**Planned Unit Development -
Lots 1 & 16 Harrison Hills—Streck, Inc.**

RECOMMENDATION REPORT

CASE NUMBER: PPUD-19-0002

RE: Planned Unit Development – Initial Review
Streck, Inc. – Harrison Hills

PLANNED UNIT DEVELOPMENT
SITE PLAN EXHIBIT

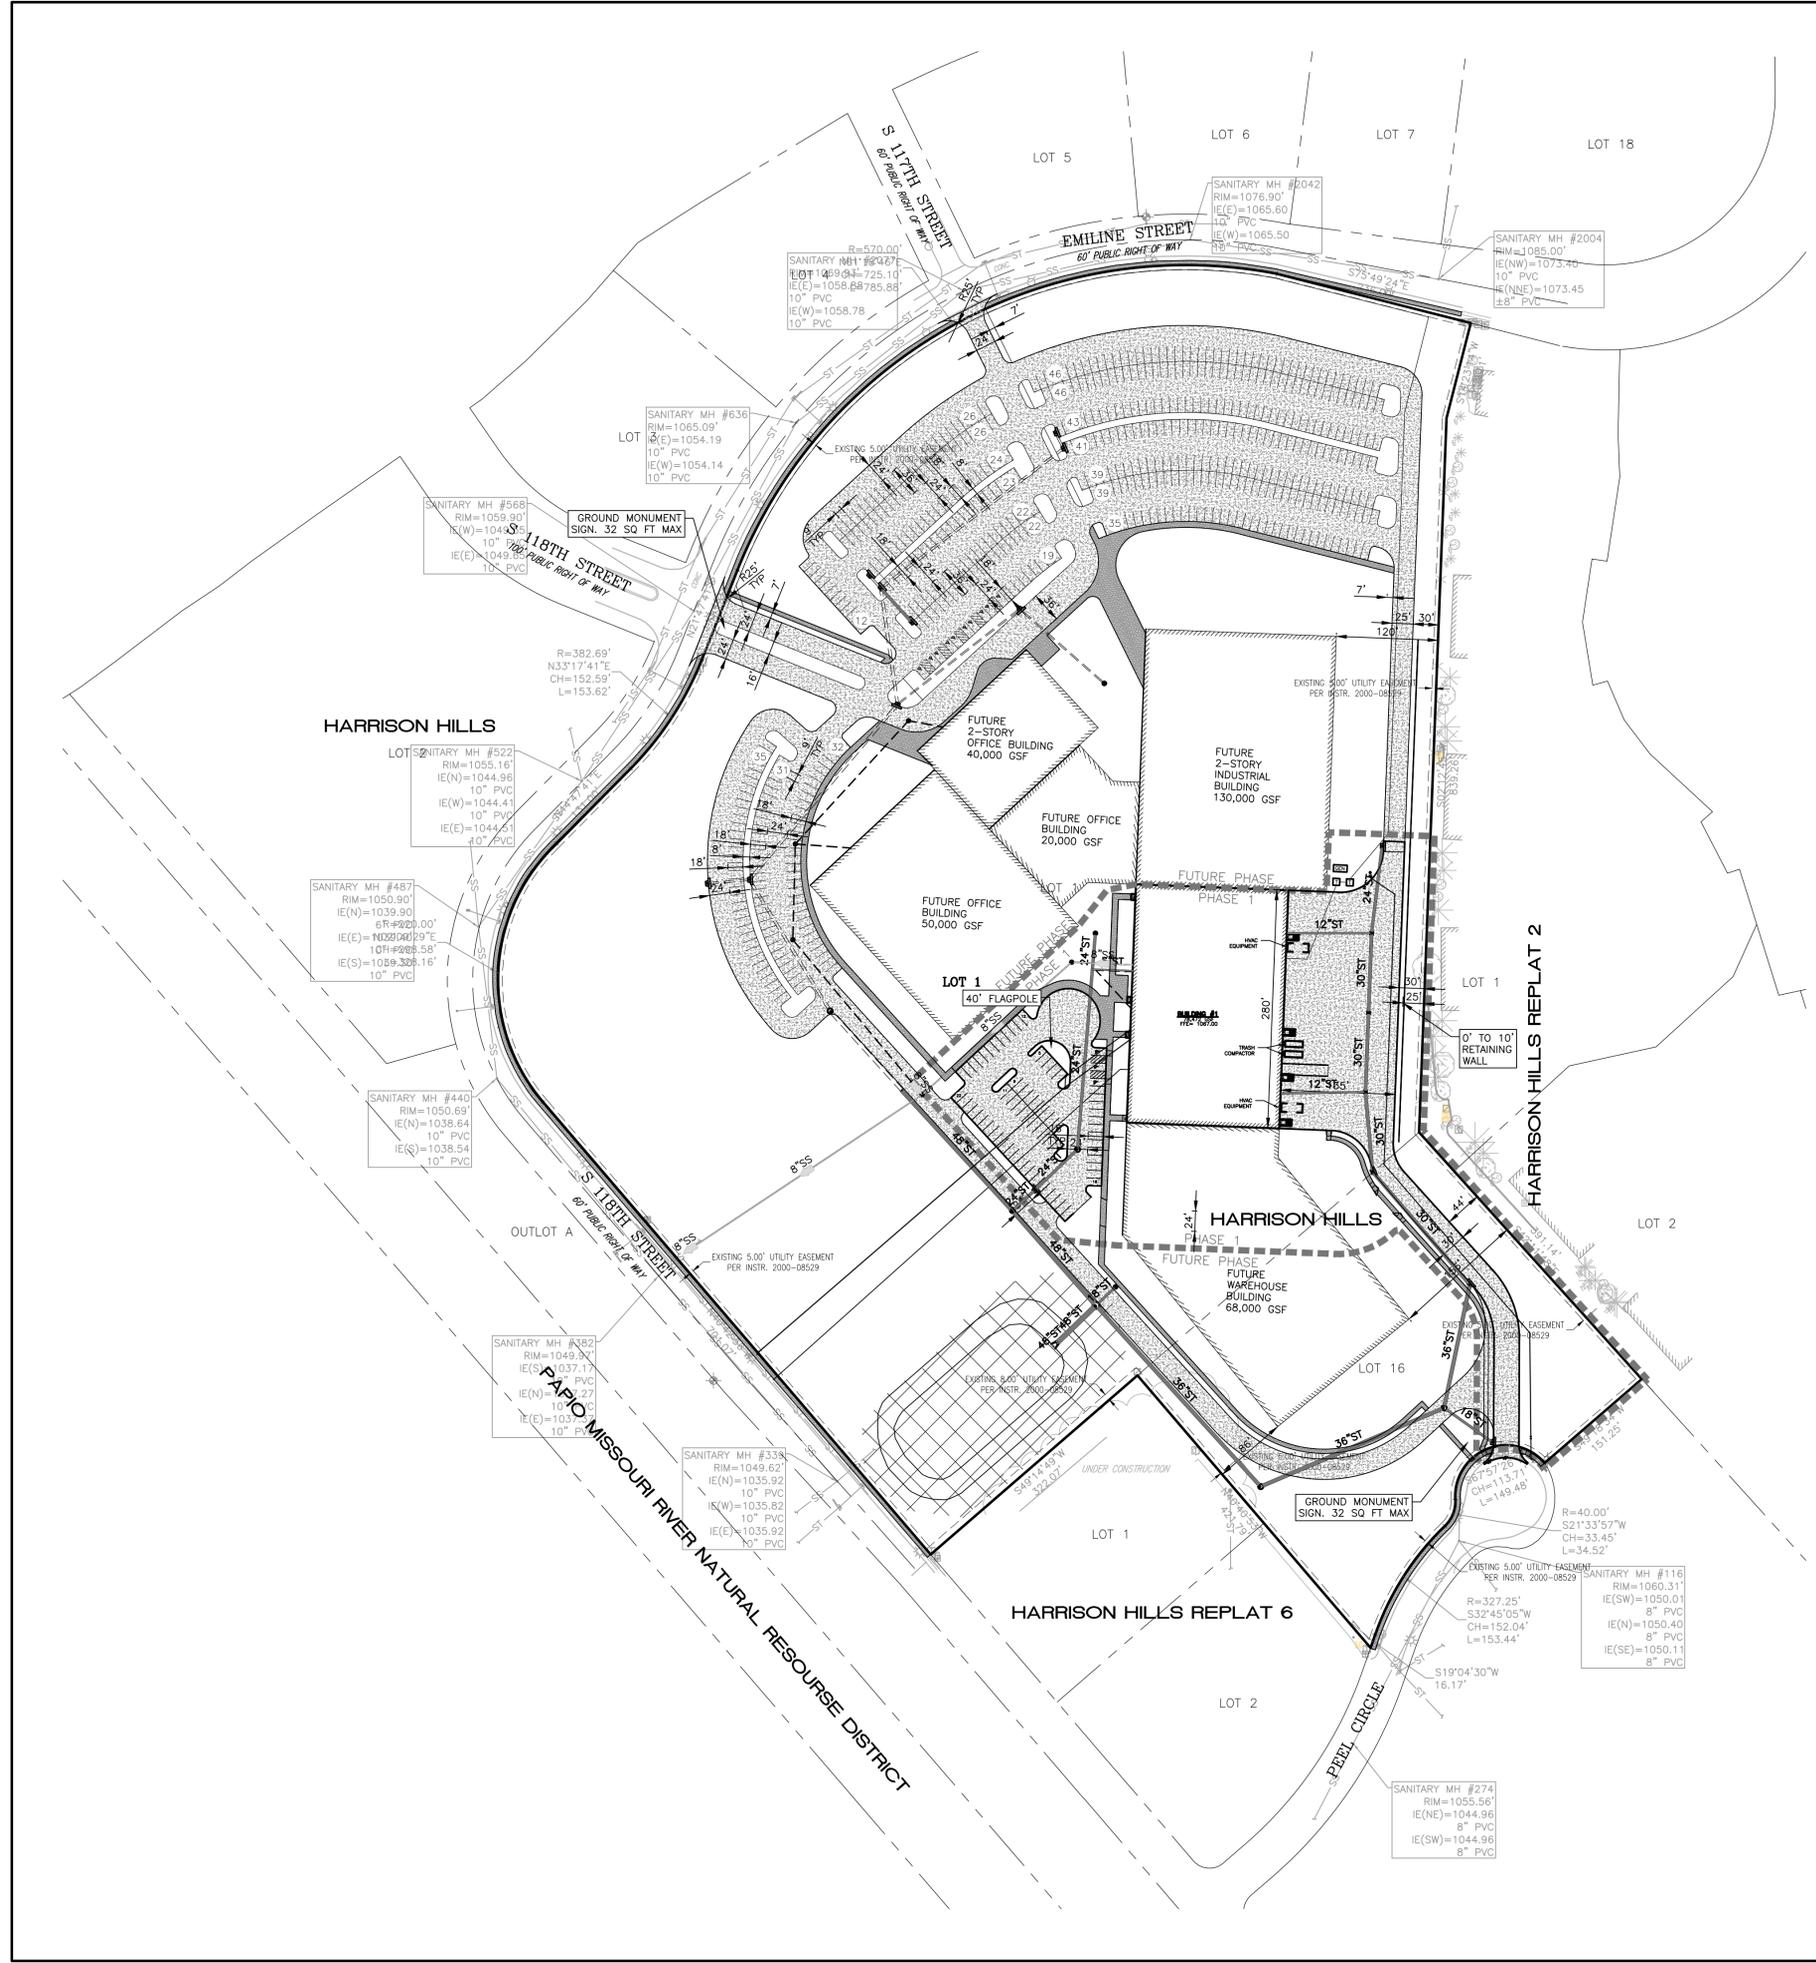
1. Section 5.15.03 – The zoning listed on the PUD Site Plan needs to be corrected to I-1 PUD, Gateway Corridor District (Overlay District) to reflect the actual zoning.

The front yard setback listed on the PUD Site Plan needs to be adjusted to include language that notes the required setback (60 feet) if there is parking in the front yard.

Signage needs to be removed from the PUD Site Plan. Additionally, a 100 square foot monument sign will not be allowed. The additional monument sign along Emiline Street at 117th will not be acceptable. A directional sign, as per the zoning ordinance, would be acceptable in this location.

1. Section 5.15.03 – The zoning listed on the PUD Site Plan needs to be corrected to I-1 PUD, Gateway Corridor District (overlay District) to reflect the actual zoning.

The front yard setback listed on the PUD Site Plan needs to be adjusted to include language that notes the required setback (60 feet) if there is parking in the front yard.

Signage needs to be removed from the PUD Site Plan. Additionally, a 100 square foot monument sign will not be allowed. The additional monument sign along Emiline Street at 117th will not be acceptable. A directional sign, as per the zoning ordinance, would be acceptable in this location.

Response: Agreed, the zoning listed on the PUD Site Plan has been updated.

Response: Agreed, the front yard setback listed on the PUD Site Plan has been updated.

Response: The request for a 100 square foot monument sign has been removed from the PUD Site plan. We have revised the PUD Site Plan to indicate two monument sign locations which will comply with a maximum of 32 square feet of sign area each.

PLANNED UNIT DEVELOPMENT
PHASING PLAN EXHIBIT

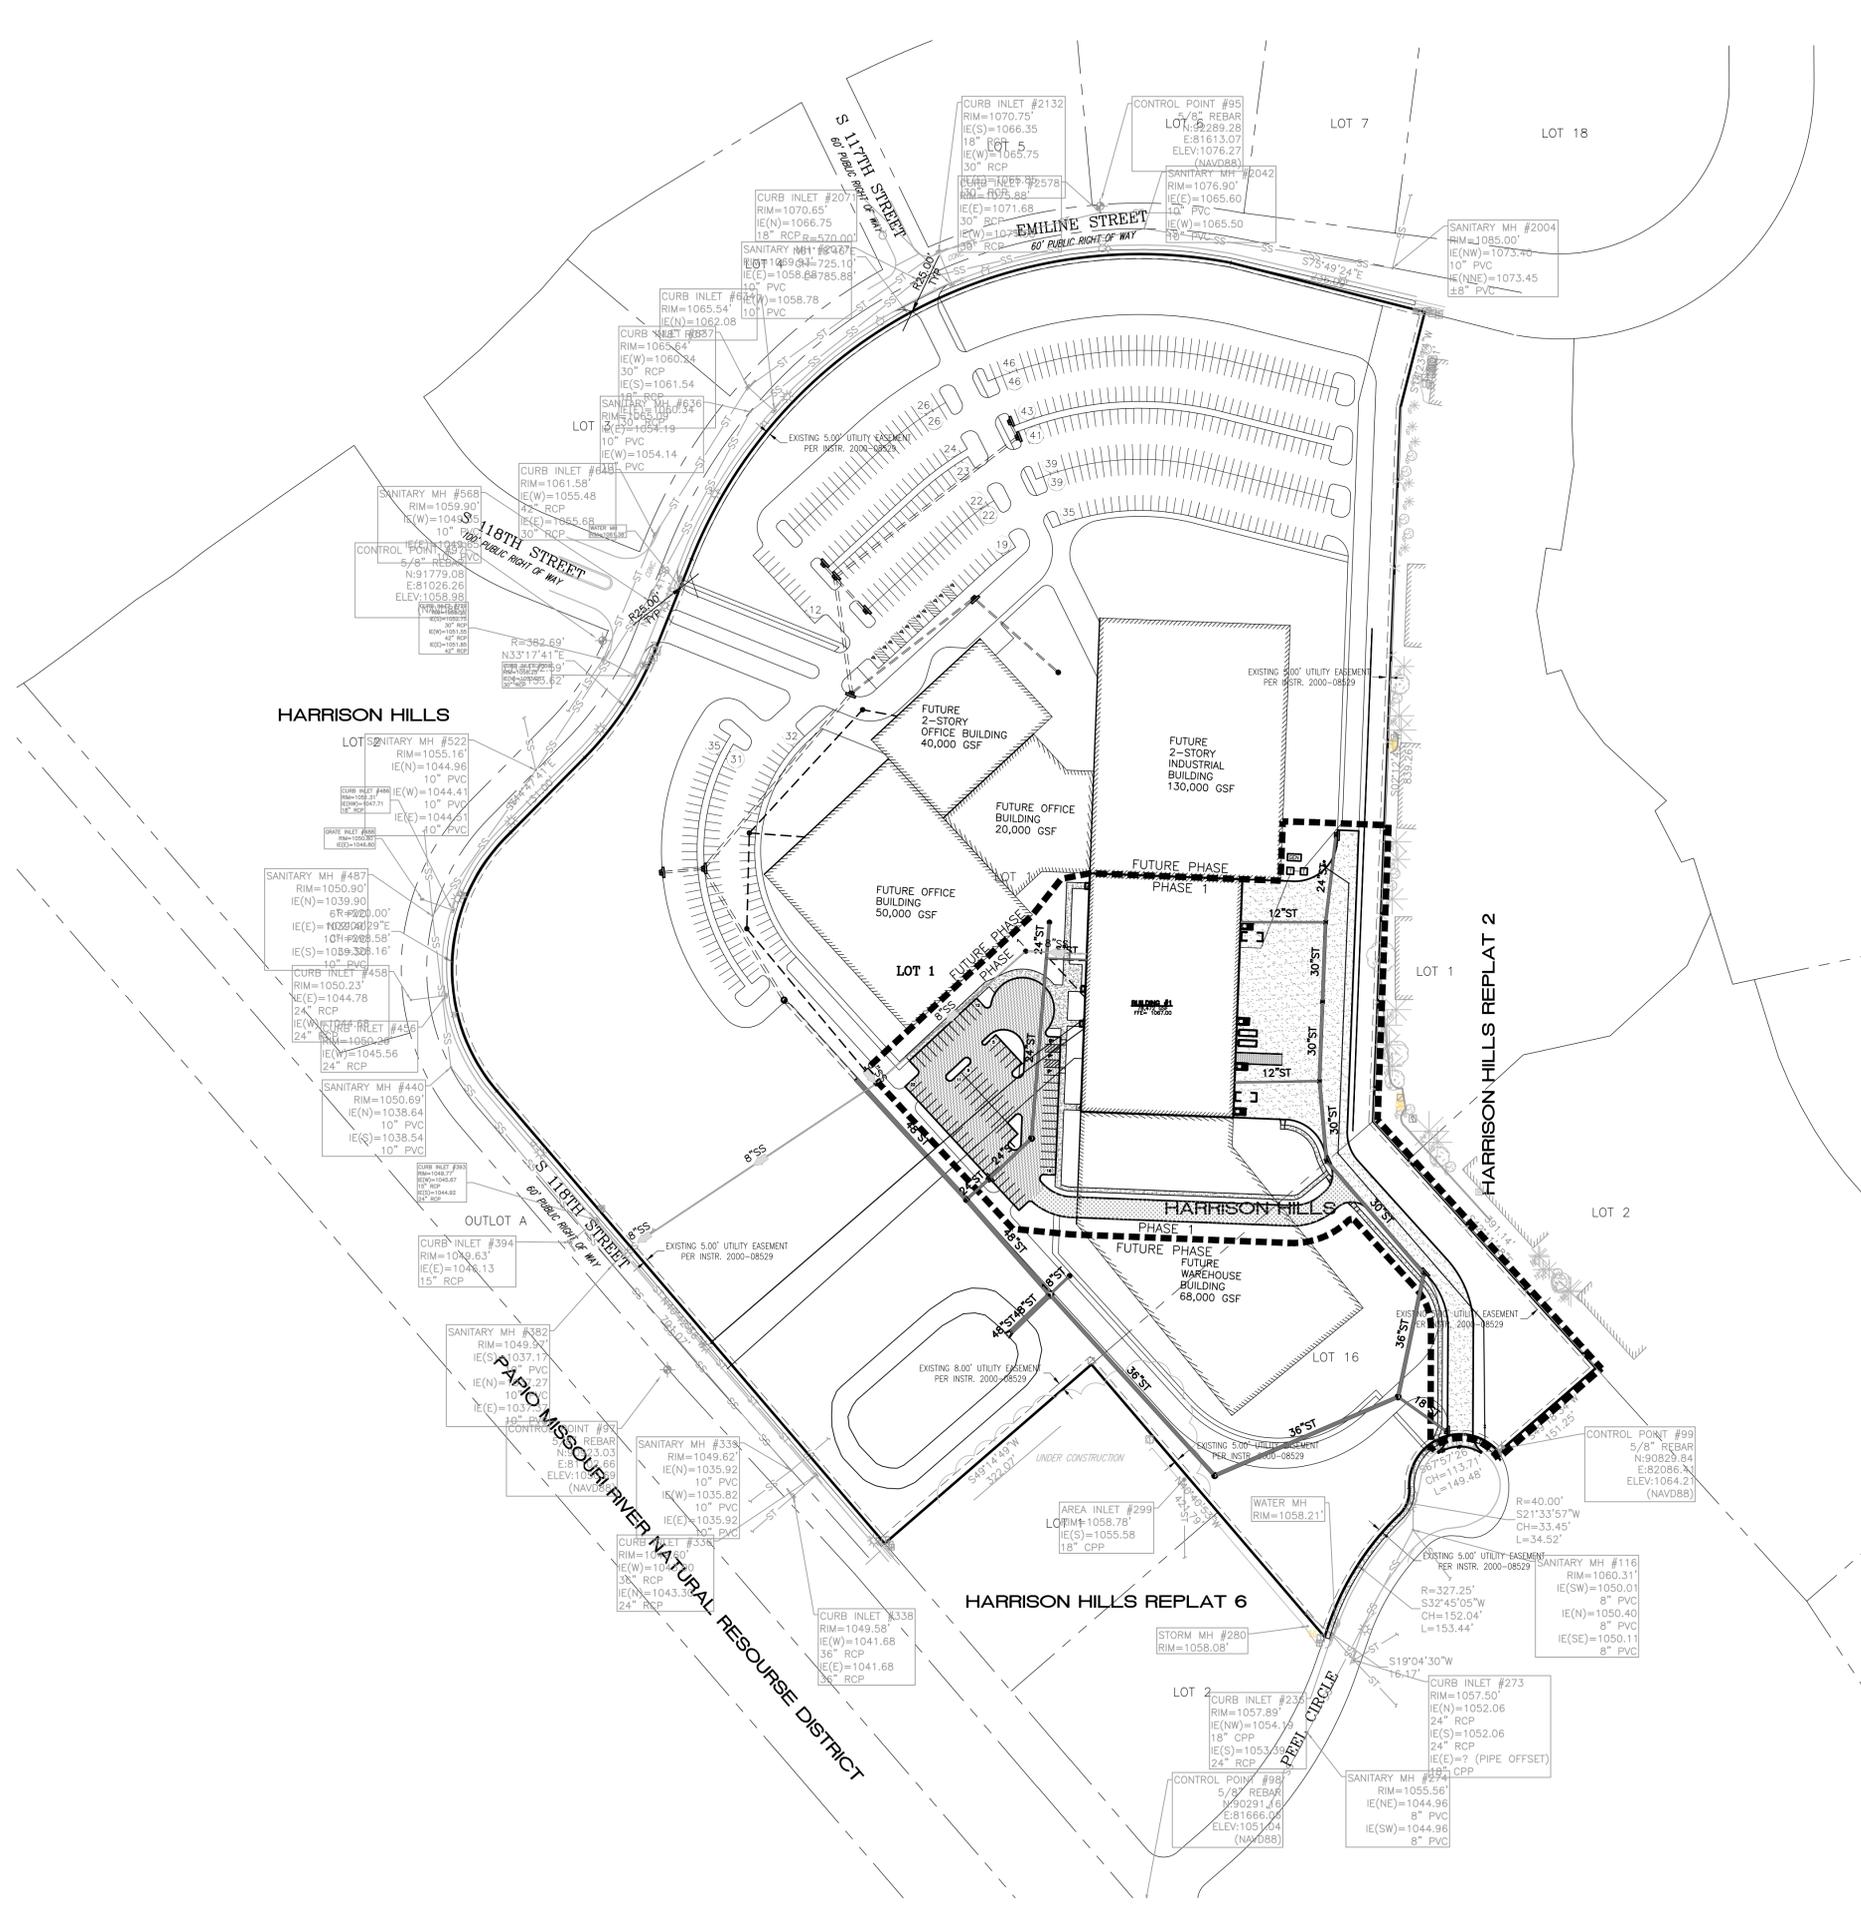
1. Comment Response # 11. Sanitary sewer connection fees and stormwater management fees were noted per the PUD Development Fee Table per the PUD Phasing Plan Exhibit, however the fee rates were not consistent with the current Master Fee Ordinance. Current Watershed Fees are \$4,963/acre (as of 7/1/19) and Sewer Connection Fees are \$7,407/platted acre (as of 1/1/2019).

6. Comment Response #11 – Sanitary sewer connection fees and stormwater management fees were noted per the PUD Development Fee Table per the PUD Phasing Plan Exhibit, however the fee rates were not consistent with the current Master Fee Ordinance. Current Watershed Fees are \$4,963/acre (as of 7/1/19) and Sewer Connection Fees are \$7,407/platted acre (as of 1/1/2019).

Response: We have added a PUD Development Fee Phase table to the PUD Phasing Plan Exhibit.

Response: The PUD Development Fee Table has been updated per the 2019 fees listed above.
